euroclamp is proud to inform you that the **series SVxx-3,5/3,81-F/-P** underwent several improvements

As of January 1, 2017, all deliveries will switch to the new style of SVxx-3,5/3,81-F/-P series

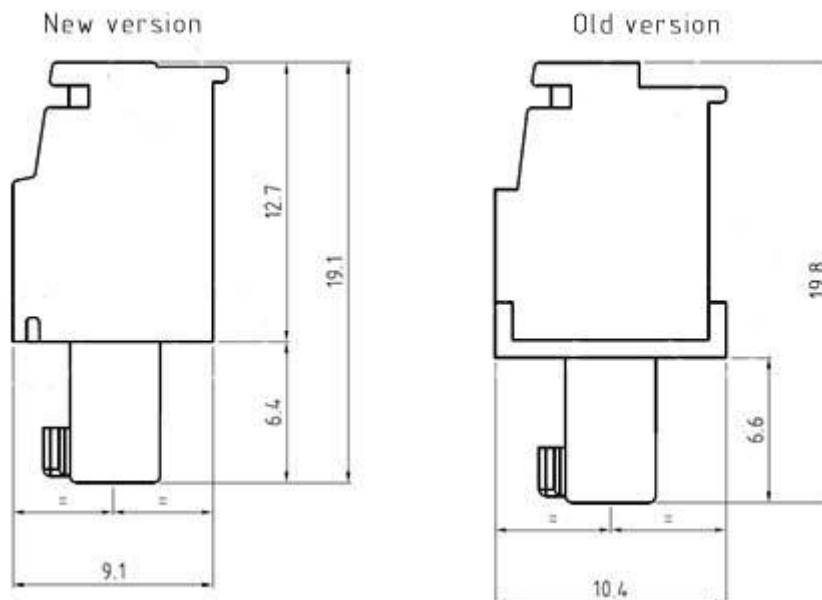
- **SVxx-3,5/3,81-F/-P series are more compact now. Total height of new style is 19.1mm instead of 19.8mm**

- **New style of SVxx-3,5/3,81-F/-P are UL approved for higher ratings now.**

UL1059	New Style	Old Style
current	11A factory 11A field	8A
voltage	300V (group B, D)	300V
wire section	14÷30AWG	14÷30AWG
torque	2.3Lb-in	1.7Lb-in
FILE	E178356	E178356
